UNITED STATES PATENT AND TRADEMARK OFFICE

| APPLICATION NO. | FILING DATE | FIRST NAMED INVENTOR | ATTORNEY DOCKET NO. | CONFIRMATION NO. |
|---|-------------|----------------------|---------------------|------------------|
| 10/600,698 | 06/23/2003 | Masakazu Okuda | 053588-5012 | 5737 |

| Office Action Summary | Application No. 10/600,698 | Applicant(s) OKUDA ET AL. AK | |

**FIG. 3**

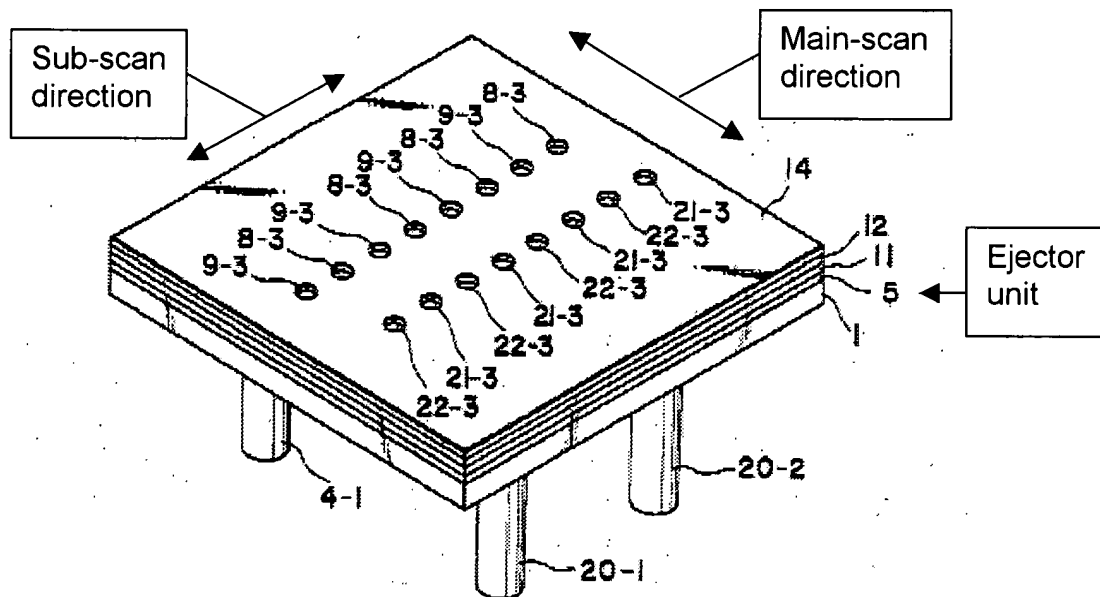
Sugitani et al. discloses, regarding claim 1, a liquid drop discharging head (figure 3) comprising one ejector unit arranged along a main scanning direction (as shown on the following page), wherein:

the ejector unit includes a first ejector group (the ejectors corresponding to nozzles 21-3 and 22-3 in figure 3) arranged at one side in the main scanning direction and a second ejector group (the ejectors corresponding to nozzles 8-3 and 9-3) arranged at another side in the main scanning direction,

each ejector includes a nozzle (the nozzles 8-3, 9-3, 21-3, 22-3 each correspond to an associated ejector 2);

all of the nozzles are offset from each other in a sub-scanning direction which is perpendicular to the main scan direction (as shown in figures 3, 7 and 8 the left column of nozzles is staggered relative to the right column of nozzles),

the nozzles of each ejector group are alternately arranged so that when they are viewed in the main scanning direction, a nozzle of one ejector of the first ejector group, a nozzle of one ejector of the second ejector group, a nozzle of another ejector of the first ejector group, a nozzle of another ejector of the second ejector group, etc. are arranged in such an order in the sub-scanning direction (as shown in figure 3 nozzles are arranged in the sub-scan direction in the order 21-3, 8-3, 22-3, 9-3, etc.)

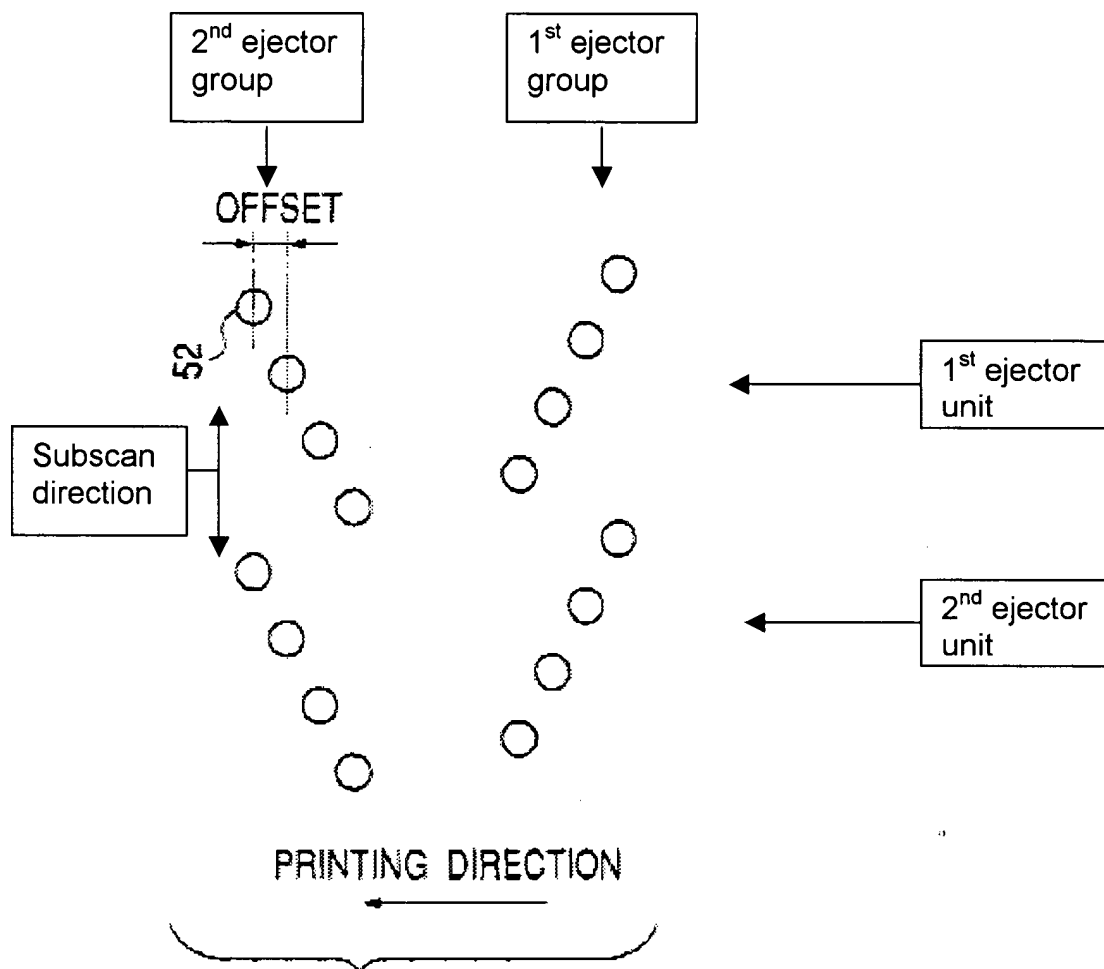
Tsuchii et al. discloses, regarding claim 1, a liquid drop discharging head (figures 1A-1C) comprising ejector units arranged along a main scanning direction (printing direction of figures 1A and 1B), wherein:

each ejector unit includes a first ejector group (shown on the following page) arranged at one side in the main scanning direction and a second ejector group (shown on the following page) arranged at another side in the main scanning direction,

all of the nozzles are offset from each other in a sub-scanning direction which is perpendicular to the main scan direction (as evident from figures 1A and 1B),

the nozzles of each ejector group are alternately arranged so that when they are viewed in the main scanning direction, a nozzle of one ejector of the first ejector group,

a nozzle of one ejector of the second ejector group, a nozzle of another ejector of the first ejector group, a nozzle of another ejector of the second ejector group, etc. are arranged in such an order in the sub-scanning direction (as shown in figure 1B nozzles are arranged in the sub-scan direction such that the uppermost nozzle of the 1st group (right side group) is arranged, followed by the uppermost nozzle of the 2nd group (left side group), followed by the second uppermost nozzle of the 1st group, followed by the second uppermost nozzle the 2nd group, etc.)

FIG. 2

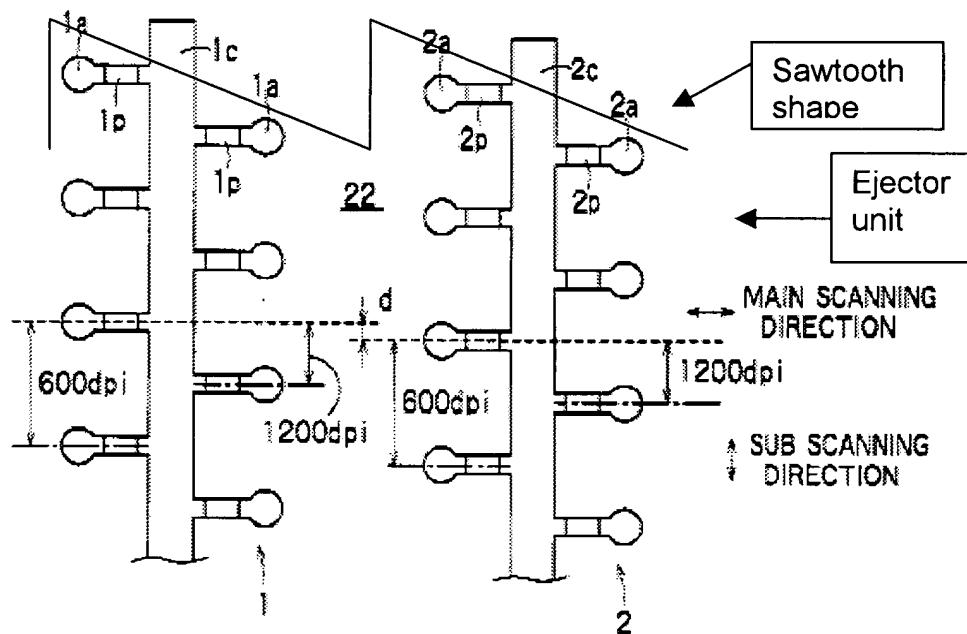
Chang discloses, regarding claim 1, a liquid drop discharging head (22) comprising an ejector unit arranged along a main scanning direction (figure 2), wherein:

the ejector unit includes a first ejector group (1) arranged at one side in the main scanning direction and a second ejector group (2) arranged at another side in the main scanning direction (figure 2, column 6, lines 17-23),

all of the nozzles are offset from each other in a sub-scanning direction which is perpendicular to the main scan direction (as shown in figure 2 and described in column 8, lines 41-49),

the nozzles of each ejector group are alternately arranged so that when they are viewed in the main scanning direction, a nozzle of one ejector of the first ejector group, a nozzle of one ejector of the second ejector group, a nozzle of another ejector of the first ejector group, a nozzle of another ejector of the second ejector group, etc. are arranged in such an order in the sub-scanning direction (as shown in figure 2 nozzles are arranged in the sub-scan direction such that the uppermost left nozzle of group 1a is arranged, followed by the uppermost left nozzle of group 2a, followed by the uppermost right nozzle of group 1a, followed by the uppermost right nozzle of group 2a, etc.)

Regarding claim 8, all of the ejectors in each ejector unit together form a sawtooth shape when viewed in a plan view as indicated on the following page.
